NCSX RFD <i>Part I</i>	Number: RFD-14-013R1	RFD Description: Change to C-4 through C-6 Flange Seats from a Spherical Seat to a Counterbore Seat
Initiator: Kevin Bowling and Phil Heitzenroeder		Organization: Major Tool/PPPL
List of Impacted Documents: (Specification, MIT/QA Plan, SOW, drawing, etc.) Drawing SE141-116		
Cost Impact: (If none, so state): None realizable; the primary motivation for this change is to save machining and inspection time.		
Schedule Impact: (If none, so state): Machining and inspecting a counterbore is much easier to perform than a spherical seat. This is expected to save several hours of machining and inspection time and expected to avoid non conformance conditions – it was not possible to achieve the tolerances required for the spherical seats on C1 and C2. These were accepted “as is” but will require time –consuming lapping at PPPL to rectify.		
Quality Impact: (If none, so state): Whereas it was not possible to achieve conforming tolerances on C1 and C2 with spherical seats, tolerance conformance is expected with the counterbores.

NCSX RFD <i>Part III</i>	Number: 14-013R1	RFD Description: Change to C-4 through C-6 Flange Seats from a Spherical Seat to

Section from SE141-116 (Datum D) Showing Location of Holes in Yellow Highlight and Circles

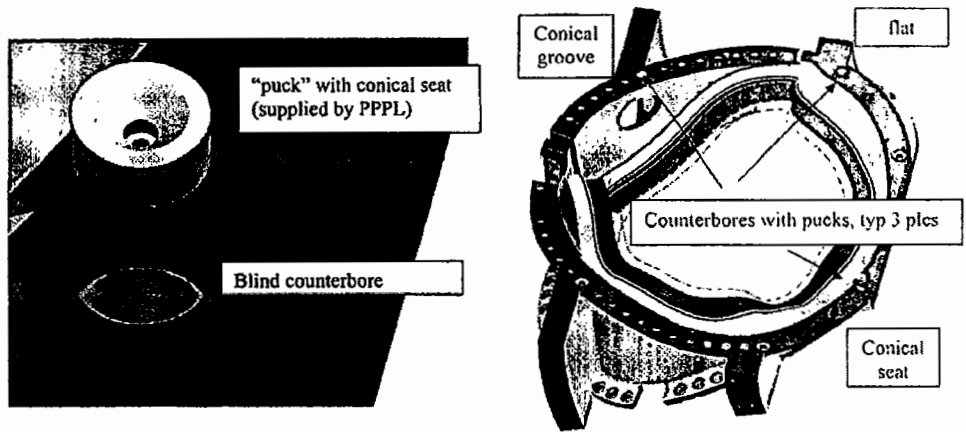
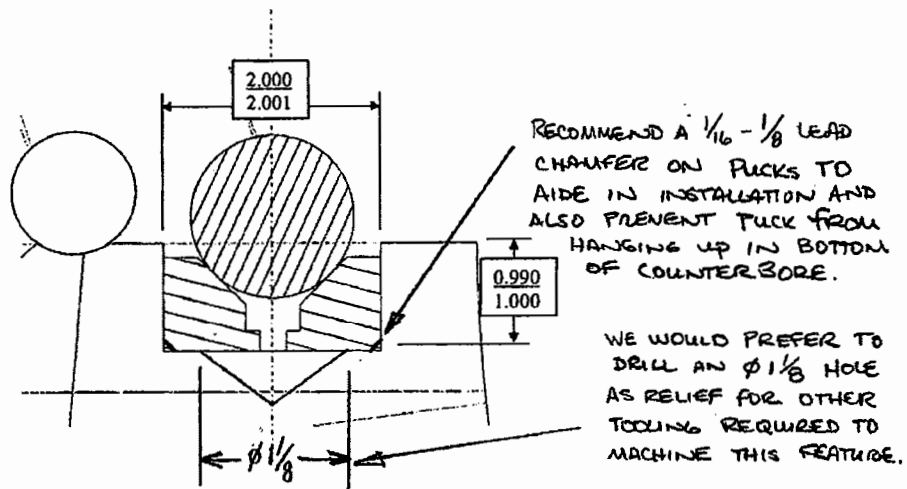
State Requirement Deviation is Requested For: (Specification, MIT/QA Plan, SOW, drawing, etc.): Drawing SE141-116		
Full Description of the Deviation Requested: (Use continuation pages, e-mails, letter, sketches, etc. as needed and include amplifying information as appropriate to support deviation request.): During technical meetings at MTM the week of January 3 rd , MTM identified difficulties encountered machining and inspecting the spherical seats on the flanges. MTM requested that consideration be given to changing the spherical seats to conical seats, starting with the C-3 casting and for all follow-on castings. Subsequently, counterbores were suggested as a replacement for the conical seats so that custom “pucks” could be inserted with an appropriate configuration (eg, conical seat, conical groove, flat) The counterbored seats should be easier to machine and inspect. See the attached figure “C3 Counterbore Seat Detail Sketch”.
